**FINAL PRODUCT/PROCESS CHANGE NOTIFICATION #16717**Generic Copy

**Issue Date:** 07-Sep-2011

**TITLE:** Final Notification of Transfer of Low Capacitance TVS (Transient Voltage Suppressor) Array products from ON Semiconductor COM1 Fab in Phoenix (USA) to ON Semiconductor Fab2 in Oudenaarde (Belgium).

## Post-Change Schematic

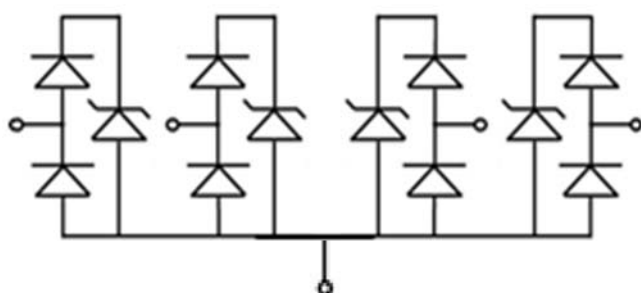
In order to facilitate certain parametric improvements during the transfer, a change was made in the part schematic (shown on the next page). The device pin out remains the same, but this change may be noted during pin to pin ICT testing. The Min VBR parameter will change from 6.0V to 5.5V.
